RE: PA 89-25 Hardee Power Station - Hardee - Vandolah Transmission Line -
SWFWMD Incompleteness Response.

Subject: Additional Information Request
Hardee Power Station
230 kV Transmission Line
(From Power Block to Existing Vandolah Sub-station)
Site Certification No.: PA 89-25
DOAH Case No.: 89-3560

SEMINOLE ELECTRIC
 TEMPORARY BRIDGE
 CROSSING OF
 PAYNE CREEK

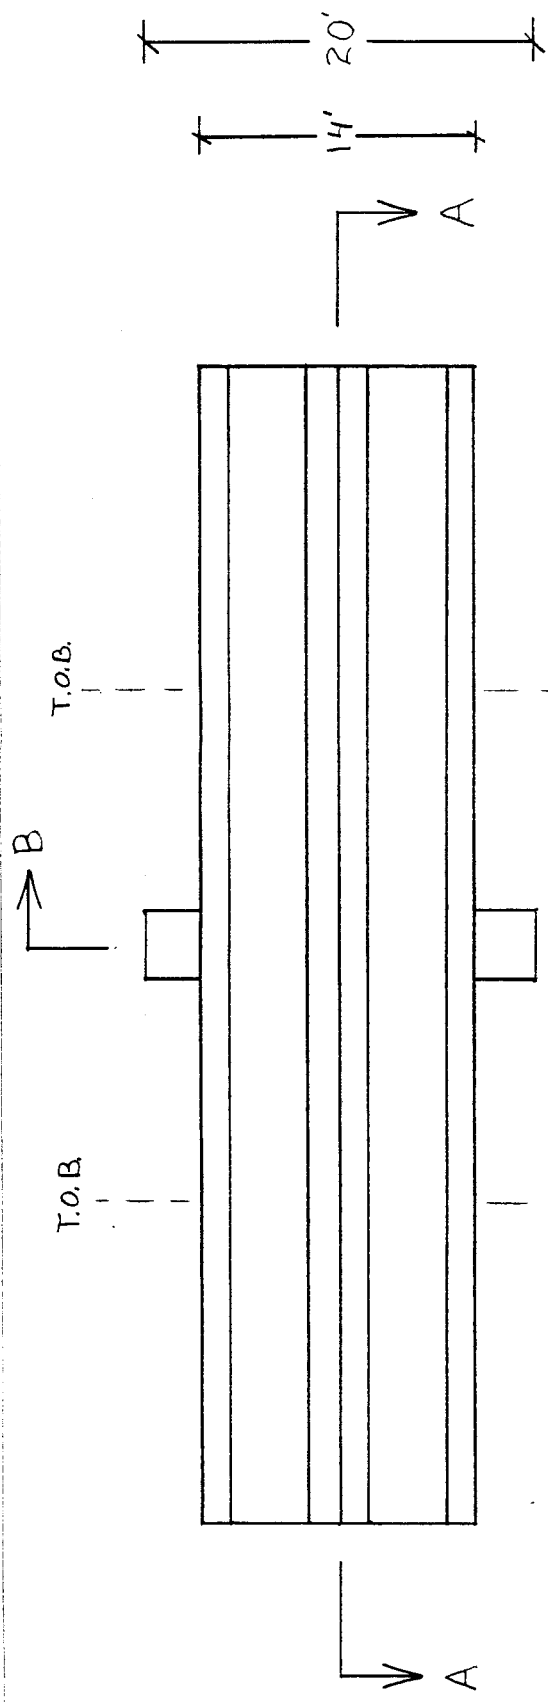
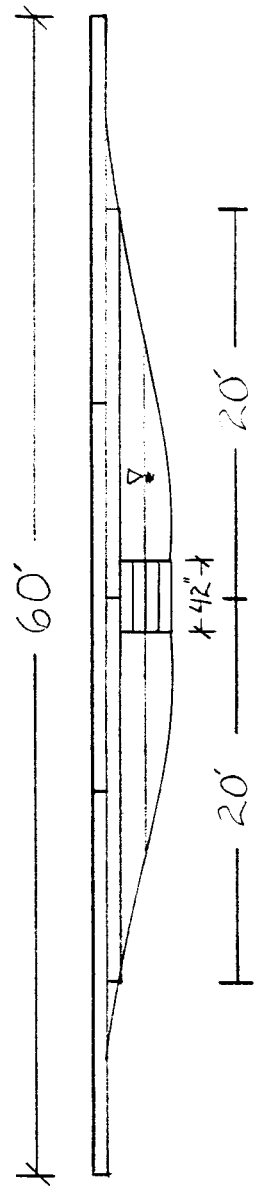
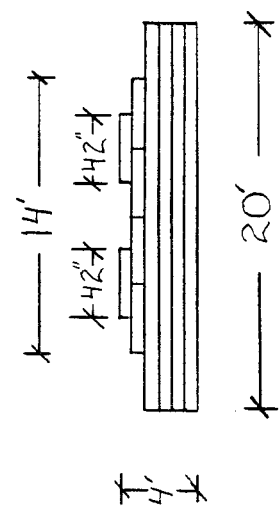
1. Please provide construction drawings (specifications and details) for the temporary wooden bridge structure to be placed in the floodplain of Payne Creek. This information needs to provide reasonable assurance that no adverse impacts (water quantity or quality) shall occur due to the proposed construction.

In response, please find the attached drawing for the temporary wooden bridge to be used to cross Payne Creek. As described in the previous incompleteness response, this bridge will be constructed of wooden mats constructed of 6"x 8" timbers designed specifically for temporary bridge construction. The only portion of the bridge that could obstruct flow is a single column of mats (42" in width) placed in a shallow portion of the channel (see the attached figure). The mats will be tied with ropes to the RR trestle or trees to prevent movement. The bridge can be removed in case of a major impending storm event. The maximum time the bridge will be in place is 2 weeks but may only be needed for 2 days if other problems are not incurred.
